TOTAL MAXIMUM DAILY LOAD (TMDL) DEVELOPMENT

For DISSOLVED OXYGEN in

BUTLER CREEK

Response to Public Comment on the Proposed TMDL

Butler Creek TMDL Location Map

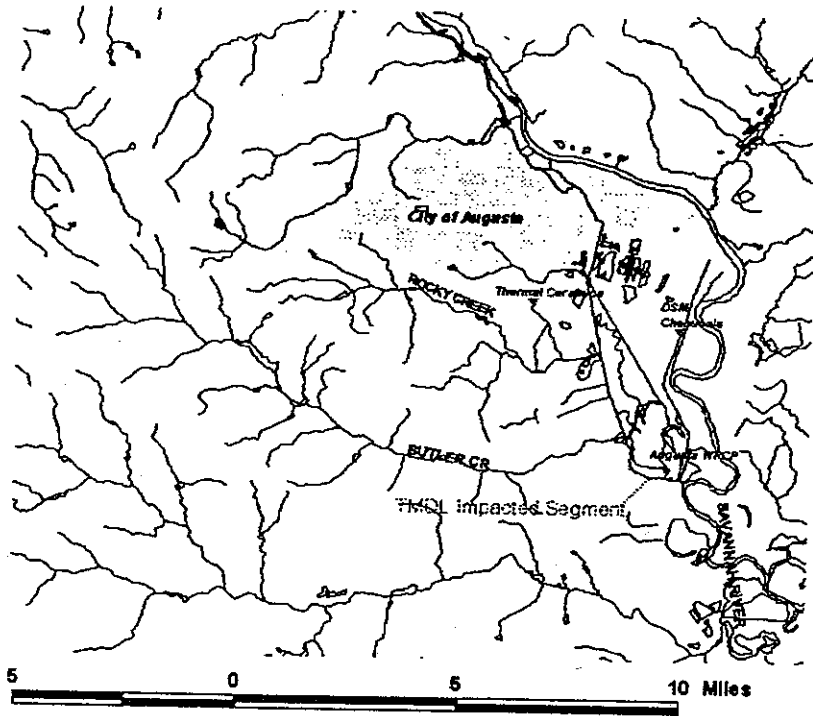
It is hard to follow in terms of location. A simple map or drawing would assist.

The final TMDL report contains a simple map of the Butler Creek watershed.
